Access Compliance Report

Public Rights-of-Way

(Curb Ramps)

Intersection ID: 13021	Main Street: COMMERCE_ST	Cross Street: S_MINT_ST	Location: N
ADA ID: AF5EC935590A	Ramp Type: PerpDiag	Initial Pass/Fail: Pass	Overall Compliance: No
		Severity Score: 32.5

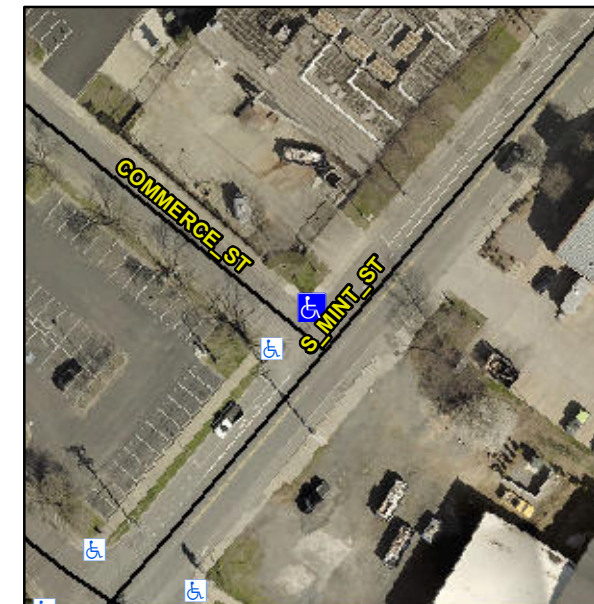
Not Found, R304.2.1, R304.2.2-Perp, R304.3.2-Para, R304.5.3, R304.2.3, R305.1.4, R305.2, R302.7.2

Remove & Replace Curb Ramp With Two New Directional Ramps or Equivalent.
